February 28, 2020

**Re: Second Adequacy Review of Amendment Application Package AM03, Arcosa  
Lightweight - Boulder, Permit M1988-108 Response to Comments**

EXHIBIT  
C-4

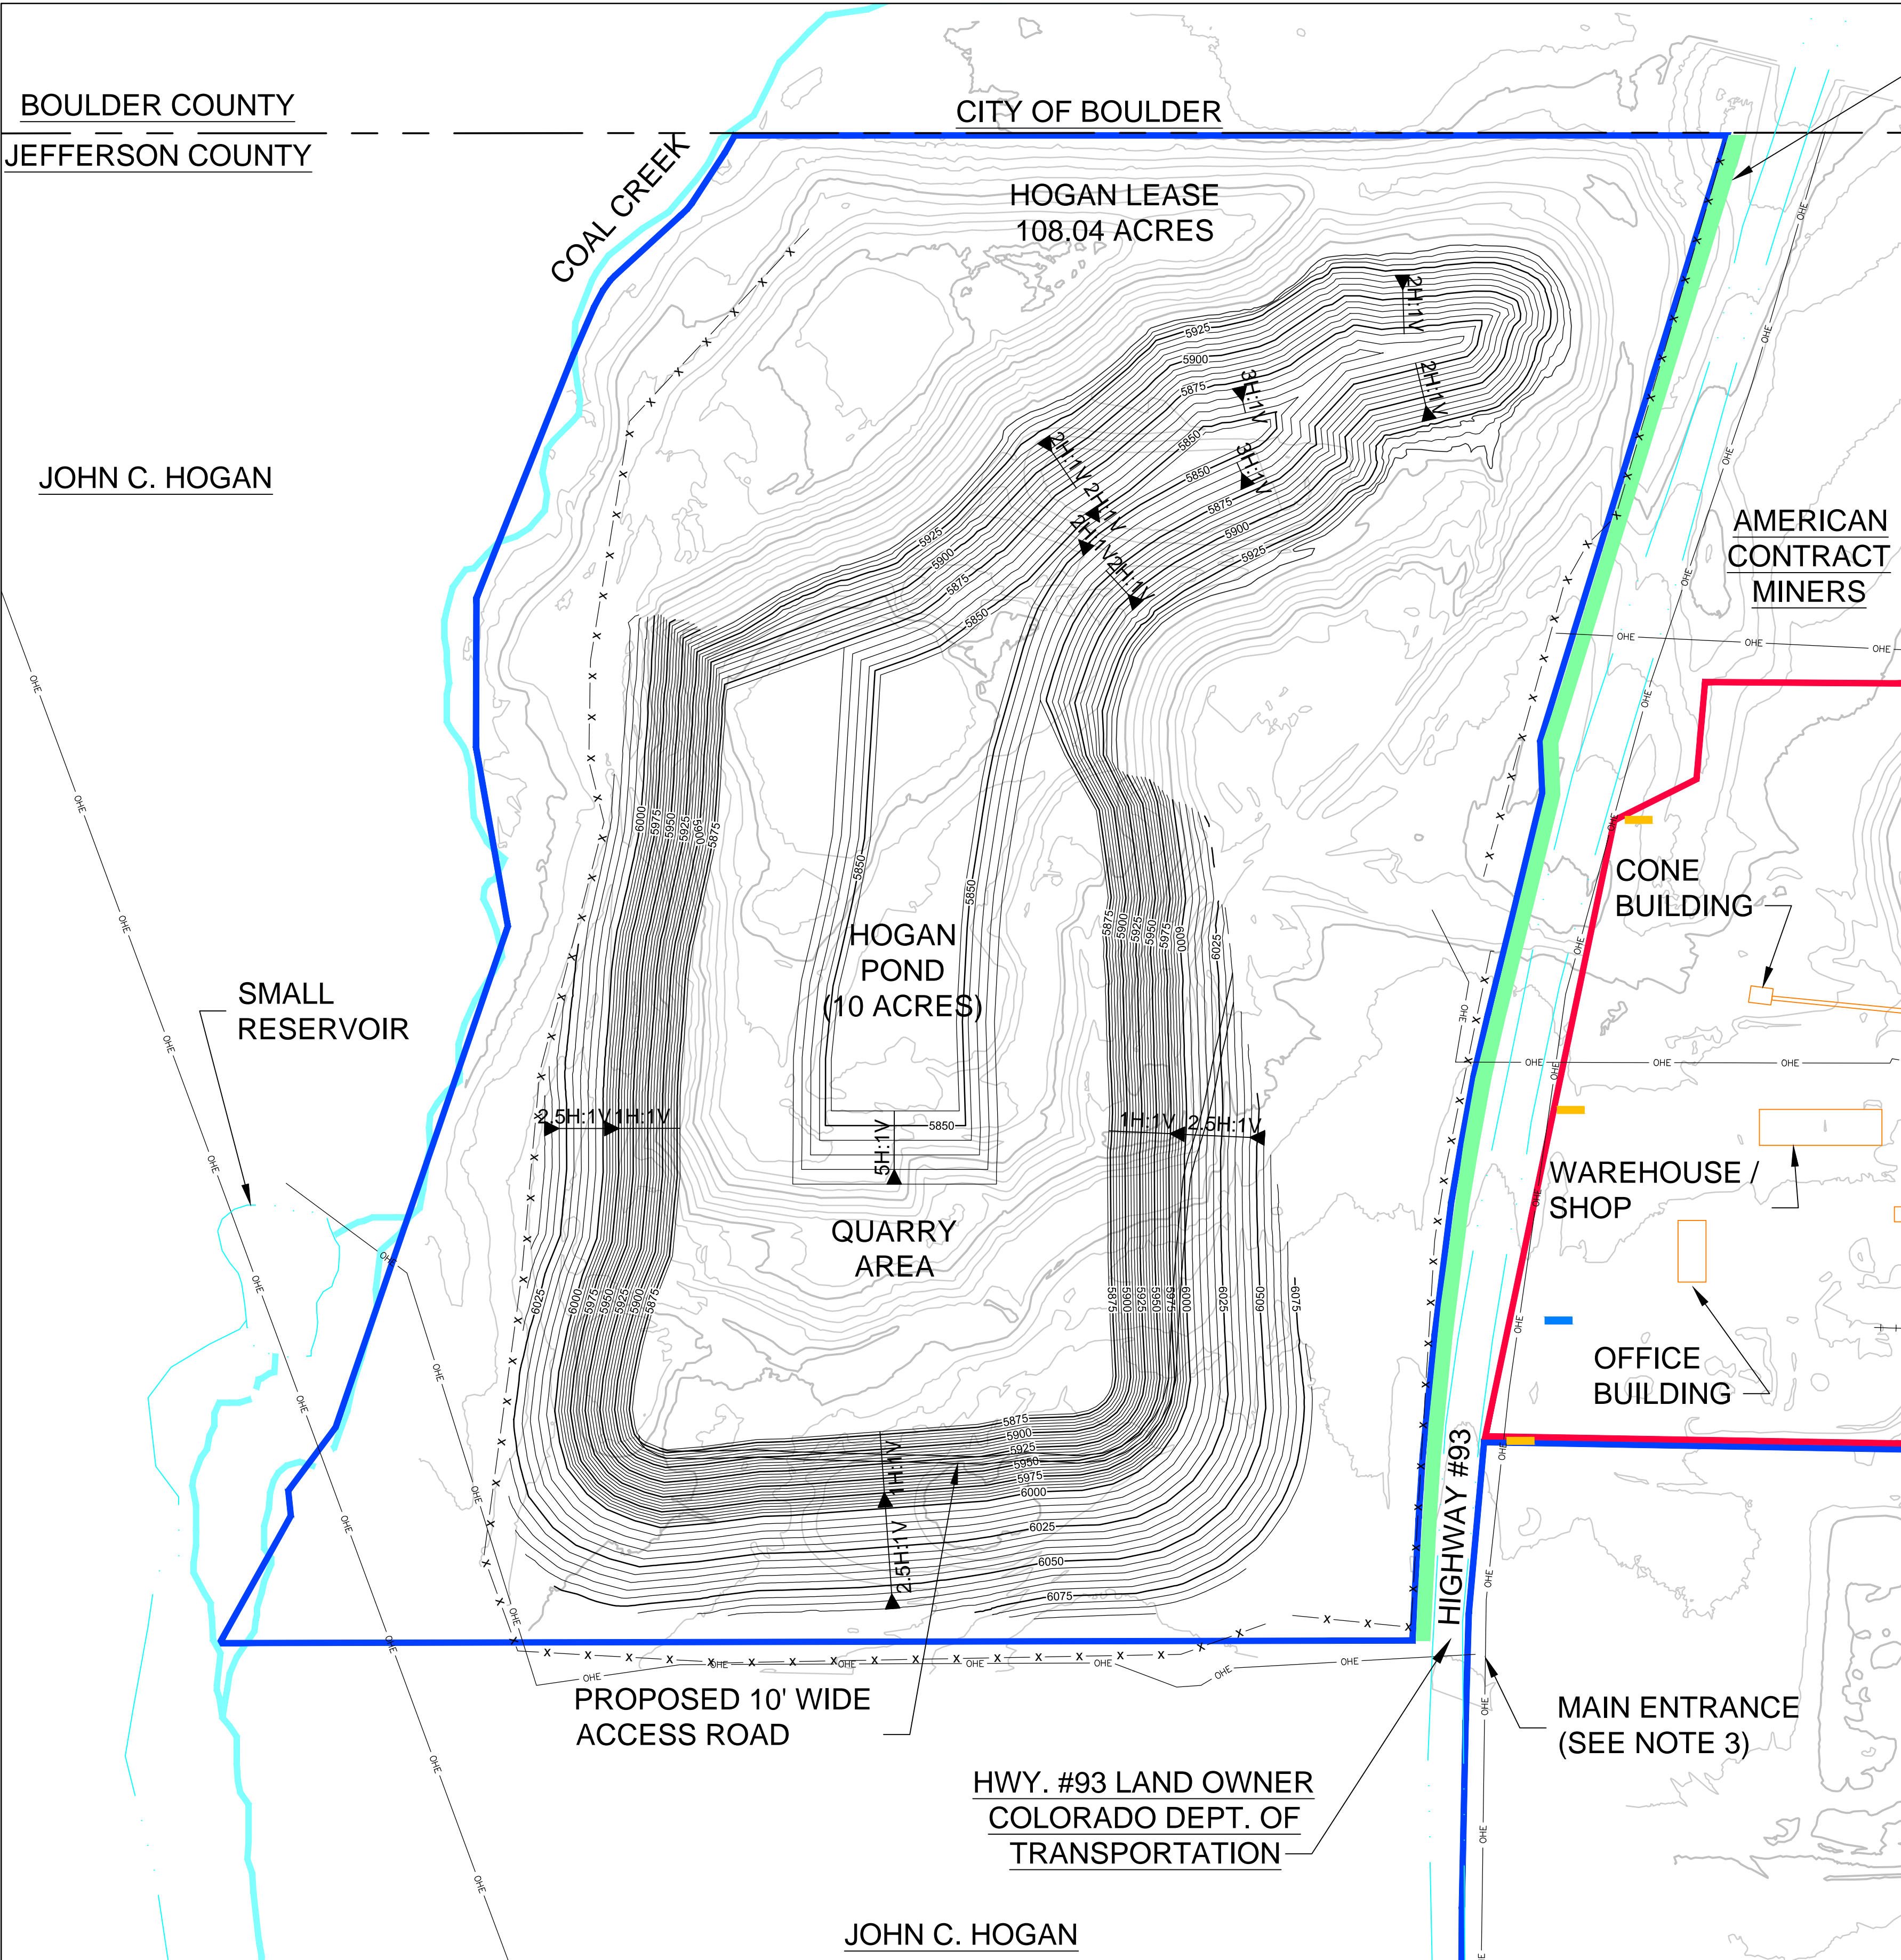
*The revised mining plan provided contains a description of how waste/off-spec materials will be placed in back into the pit. The method described is stated as:*

- 1) Waste is staged by trucks along the contours of the side walls of the quarry, then;*
- 2) Pushed by dozer over the edge of the quarry sidewall allowing the material to slope down the side of the quarry.*

*The Division is having difficulty understanding, based on the descriptions provided, how this method is substantially different from the previous waste disposal method of end dumping the waste directly over the edge of the pit to form angle-of-repose slopes along the pit walls. Could you please clarify the difference between these two waste placement methods? Perhaps a simple diagram or two illustrating the differences would be useful. Please elaborate/provide additional detail for the statement that “new material will be placed in lifts as originally planned.”*

Exhibit D has been updated to further clarify the method for future placement of backfill to achieve reclamation grades. The updated Exhibit D is provided in Attachment 1. In summary:

1. Backfill will be end-dumped from the edge of the pit into the quarry.
2. End-dumped material will then be graded using a bulldozer or other equipment such that the material is spread across the area of active backfilling, track-walked to provide some degree of compaction, and graded to shape the final restoration slopes.

The statement “new material will be placed in lifts as originally planned” has been removed to avoid confusion. Individual lifts will not be placed and compacted; rather, as stated above, a bulldozer will re-work the end-dumped material by grading and track-compacting the materials to achieve the final reclamation slopes.

Furthermore, Arcosa has developed a mine plan figure to accompany the updated Exhibit D. The mine plan figure is presented as Exhibit C-4 and is also provided in Attachment 1 to this letter. The mine plan represents Arcosa’s anticipated maximum extent of mining within the quarry area. The figure was also used to update bond calculations as required for Exhibit L, which is discussed later in this letter. Arcosa will adhere to the mine plan (Exhibit D) and the mining plan figure (Exhibit C-4) provided in Attachment 1. If a deviation(s) from these documents is proposed, Arcosa will submit a technical revision.

R:\DE0374\_ARCOSA MINE PERMIT SUPPORT\CAD\SHEET FILES\EXHIBIT F-1 - Last Saved By: SGallegos on 9/23/19

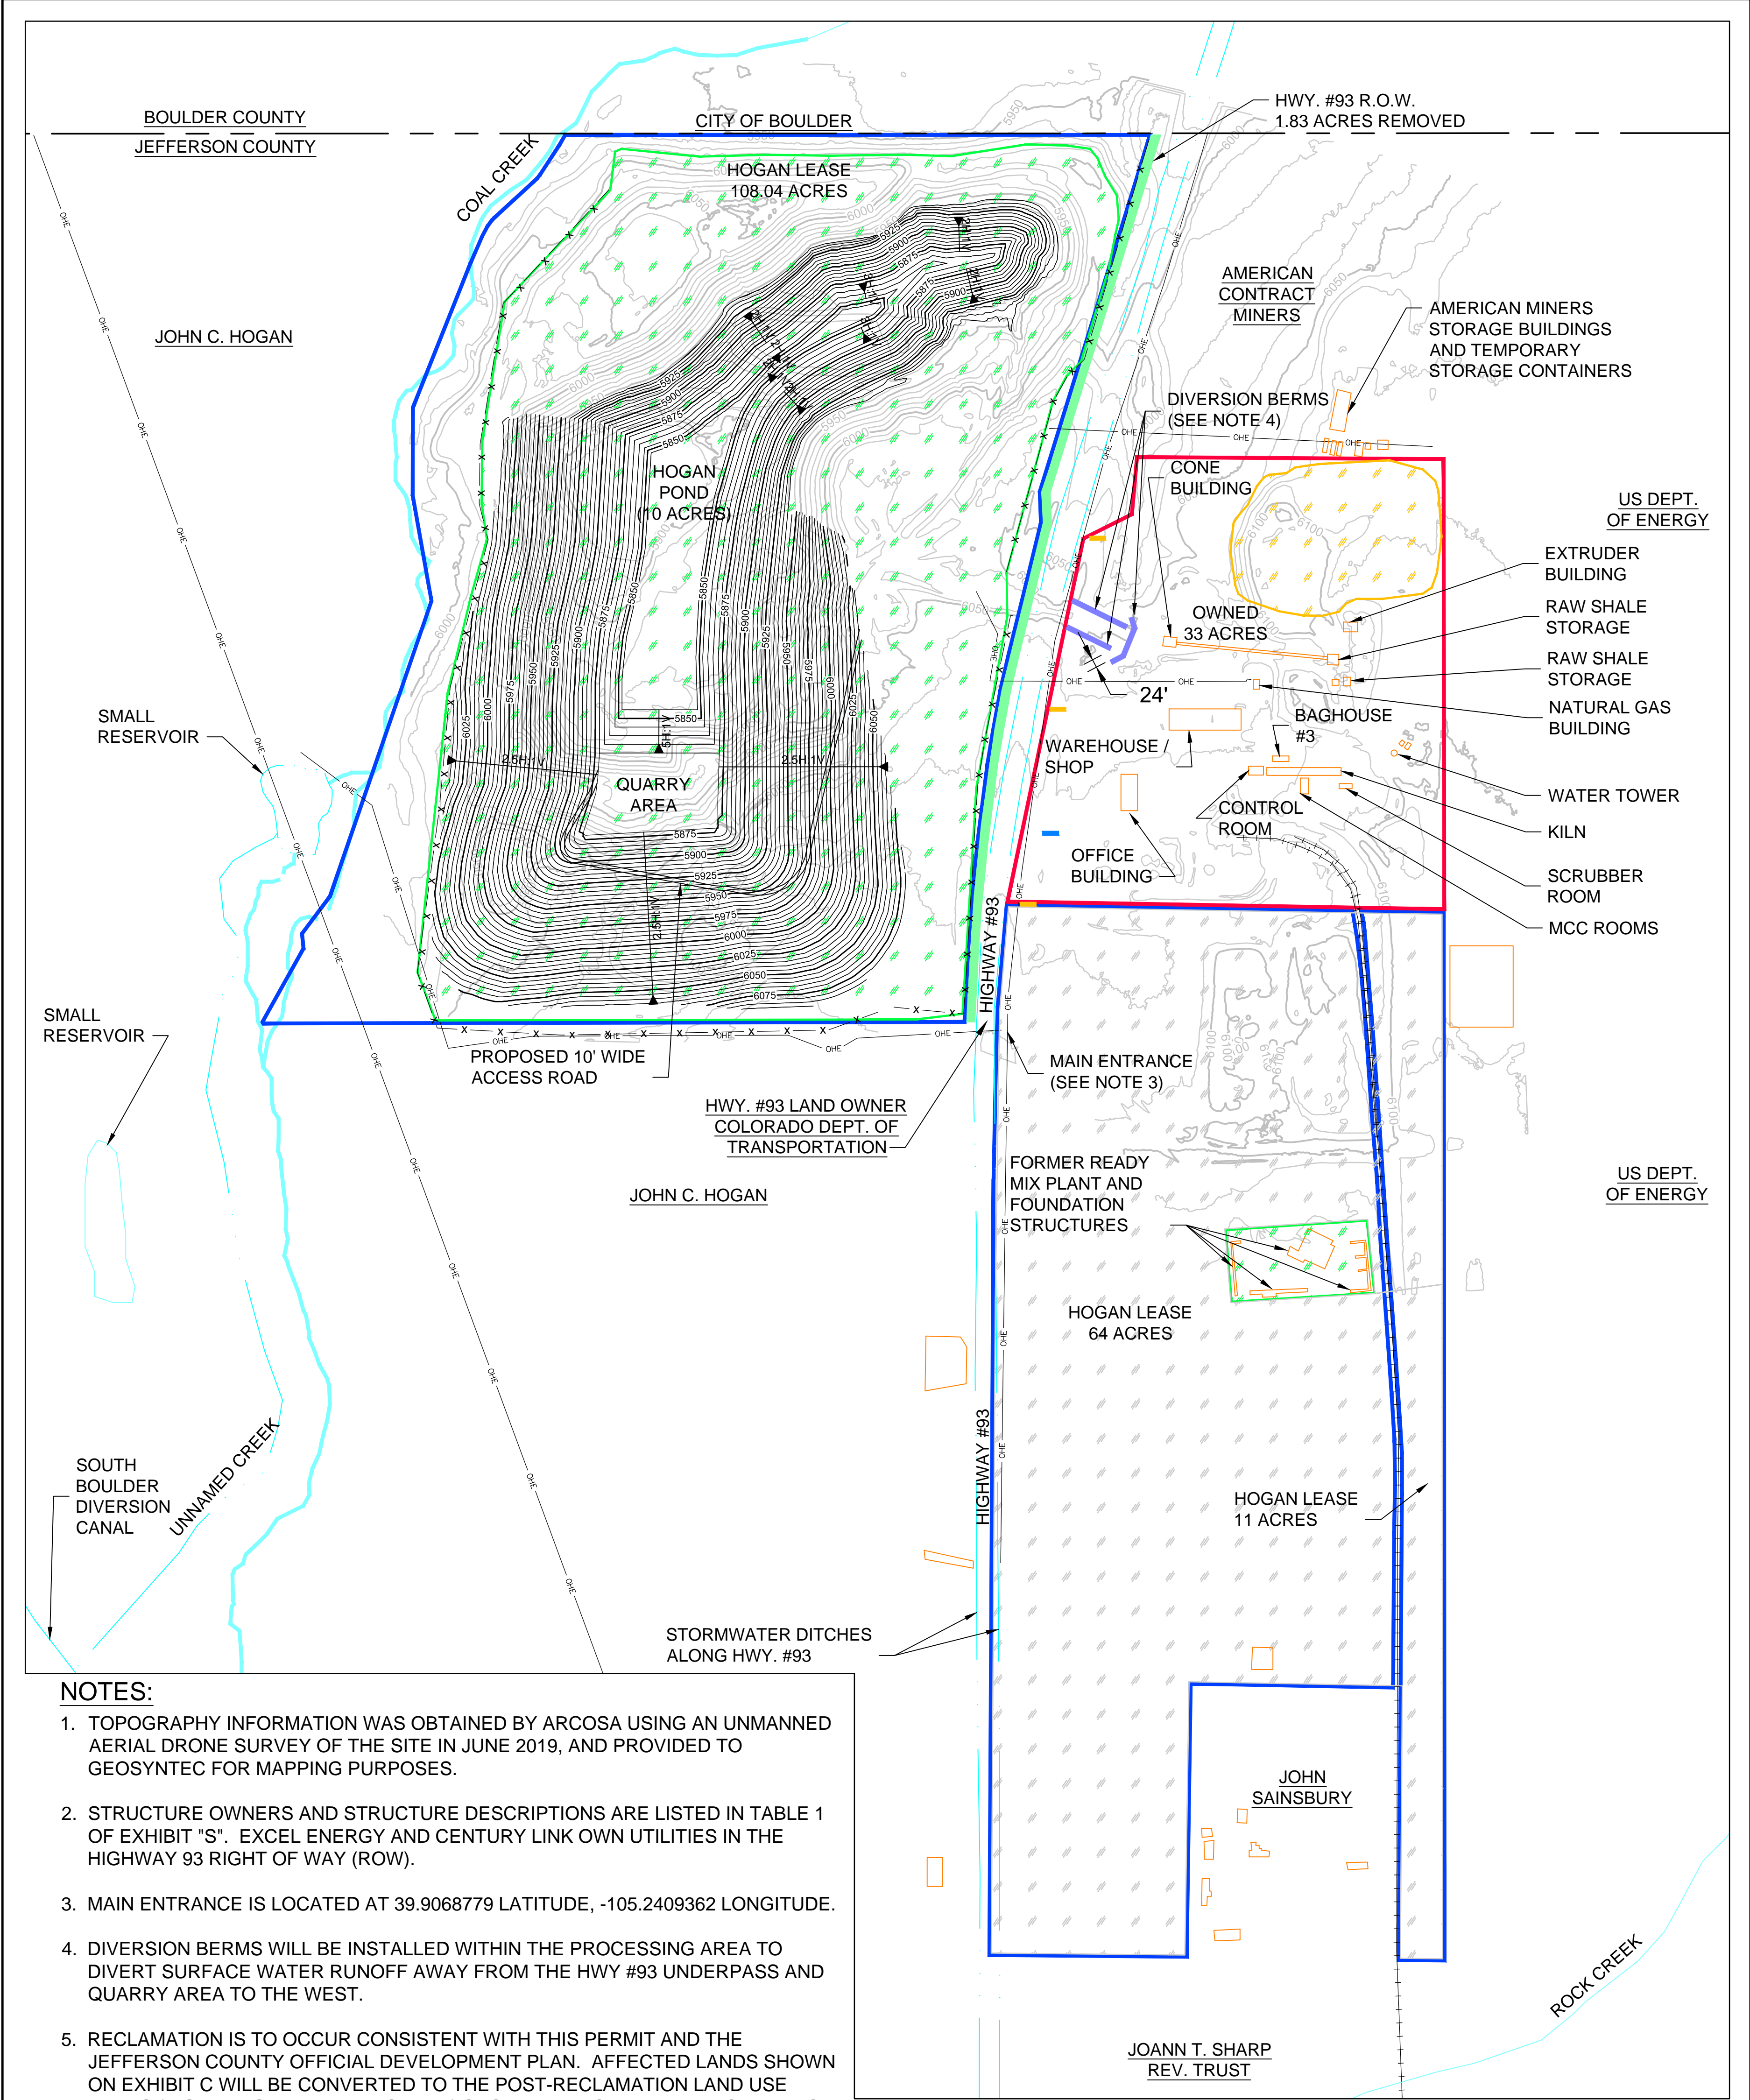
*Please specify what buildings will remain in the process area after reclamation and what buildings will be removed, and make this clear on the reclamation map. Stating that unnecessary industrial buildings and equipment will be removed does not provide sufficient detail for the calculation of that portion of the reclamation bond.*

*Please show what buildings will remain at final reclamation within the processing area.*

See attached updated reclamation plan and updated reclamation maps in Attachment 2. At this point, Arcosa assumes all existing buildings within the processing area will remain in place. This final configuration is consistent with the zoning plan for Jefferson County, as described in the Jefferson County Official Development Plan.
